SEWAGE DISPOSAL TESTING
STATE OF MARYLAND - DEPARTMENT OF HEALTH AND MENTAL HYGIENE

TITLE PERCOLATION TEST & SURVEY PLAT		ENGINEERING PLANNING SURVEYING BY BOENDER ASSOCIATES INC. BALTIMORE, MD. 21207 SALISBURY, MD. 21781 WESMINSTER, MD. 21157
PROJECT	Lot 2A JOSEPH A. CONNOLLY PROPERTY	
LOCATION	FIFTH ELECTION DISTRICT - HOWARD CO., MD.	
DATE: 2-12-75	DESIGNED BY: P.D. CHECKED BY: JLS	
SCALE: 1" = 100'	JOB NO.	DRWG. NO.:

RE: Final Plat Connolly Prop. (F-75-10)

RE: Cornwally Prop F 75-10

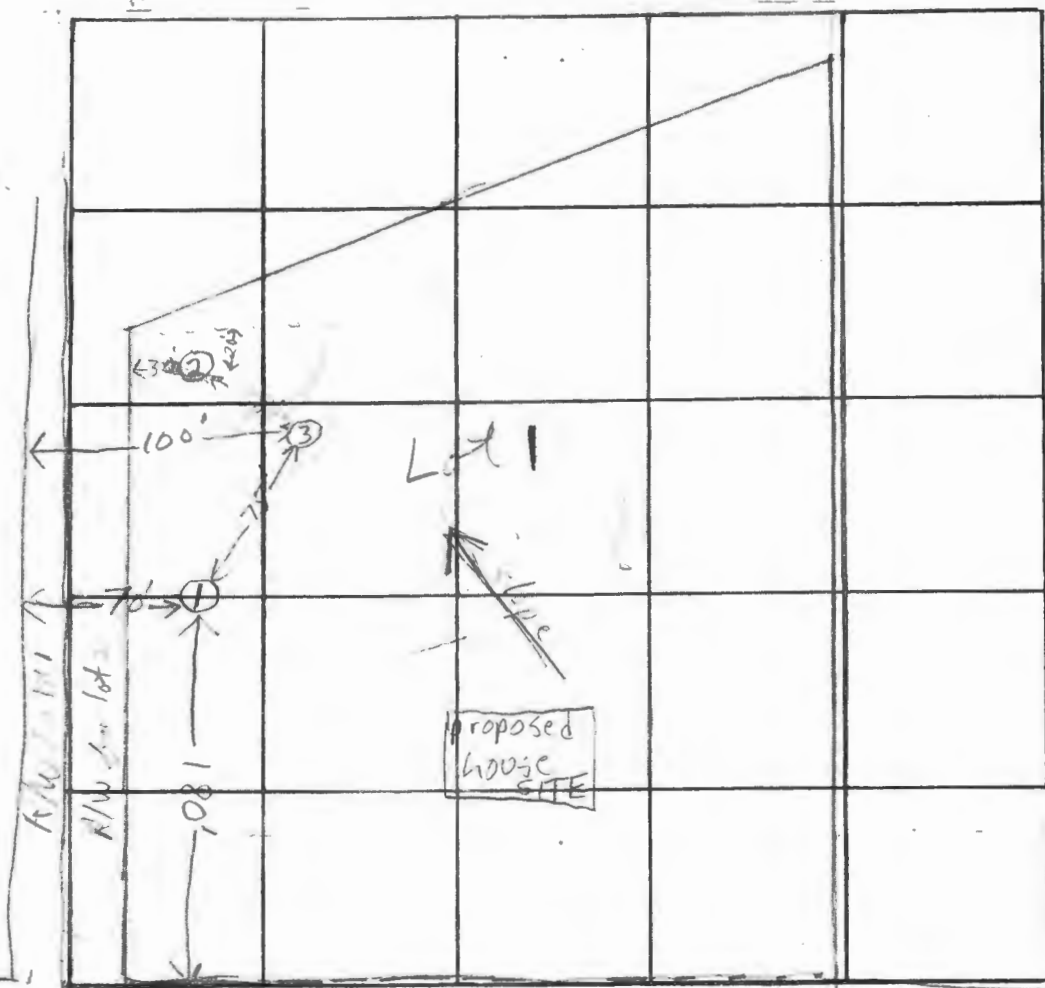
Drywell to have 156 sq. ft. effective sidewall absorption area per bedroom to begin below the first 5 ft. of non-porous soil. Maximum depth permitted for drywell is 12 ft. below original grade. Place the drywell 140 ft. from the front lot line and 130 ft. from the left side line as seen when facing the property from Pindell School Road.

lot 1

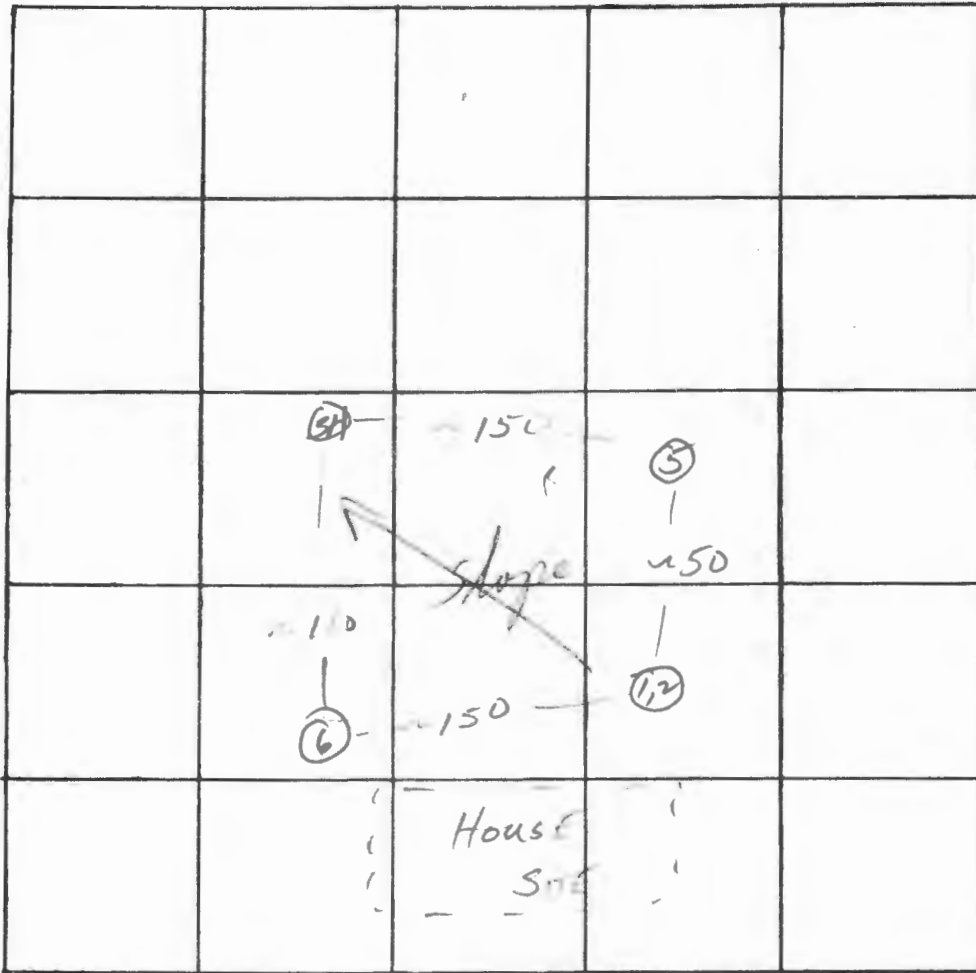
REMARKS Certify test holes!

R/W chg. Right to left
but distance to side
line same?

also chg.?

test holes staked, then
tested & plat submitted
then all changed to
lot to front?

notice given to
~~contract~~ and Eng. to office
for conference
Corners must be
staked, where pt. to
pt. cannot be seen
on line stakes
between points necessary
